State of New Mexico  
Energy, Minerals and Natural Resources

WELL API NO. 30-025-07596
5. Indicate Type of Lease STATE <input type="checkbox"/> FEE <input checked="" type="checkbox"/>
6. State Oil & Gas Lease No.
7. Lease Name or Unit Agreement Name South Hobbs (G/SA) Unit
8. Well Number: 059
9. OGRID Number: 157984
10. Pool name or Wildcat Hobbs (G/SA)

**SUNDRY NOTICES AND REPORTS ON WELLS**  
(DO NOT USE THIS FORM FOR PROPOSALS TO DRILL OR TO DEEPEN OR PLUG BACK TO A DIFFERENT RESERVOIR. USE "APPLICATION FOR PERMIT" (FORM C-101) FOR SUCH PROPOSALS.)

## SHU 59 Current Wellbore Diagram (as of August 2018)

## SHU 59 Proposed Wellbore Diagram (after P&A)

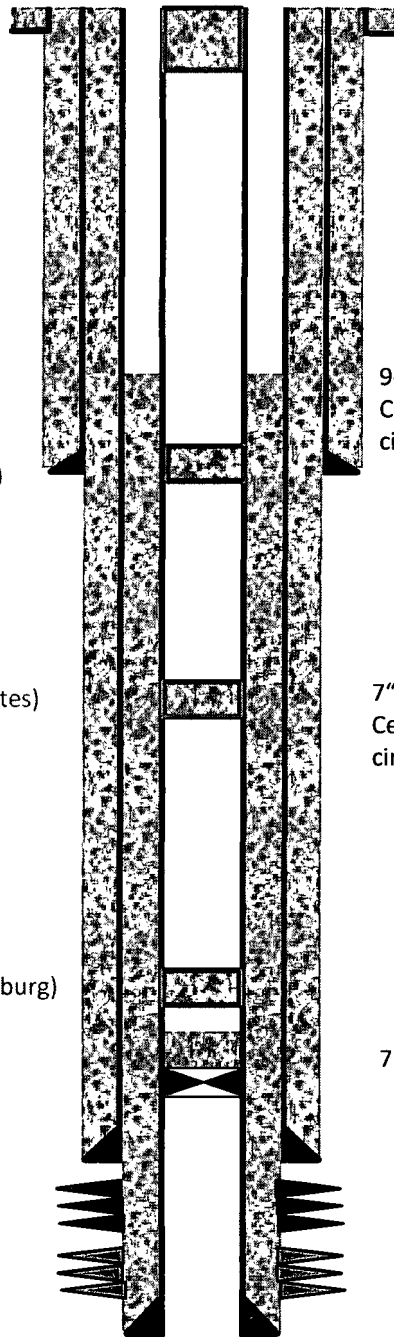
Ensure to circulate mud laden fluid between all cement plugs.  
Use closed-loop system per ODC rule 19.15.17

1. MIRU PU
2. Tag TOC to verify it is at 3934' (within Grayburg). Circulate MLF
3. Pressure test casing up to 500# @ 3934'
4. Spot 25 sx from ~~3784'-3884'~~ (Grayburg)
5. Spot 25 sx from 2754'-2844' (Yates).
6. Spot 25 sx from 1620'-1720' (shoe). Tag TOC
7. PU to 450' and spot 40 sx. Top off well as necessary. ← Perf & Circulate cmt to surface
8. Cut off wellhead and install dry hole marker with labeling ← Verify cmt to surface all strings
9. Clean up location, remove anchors

C103 INTENT TO P&A EXPIRES  
1 YEAR FROM DATE OF APPROVAL
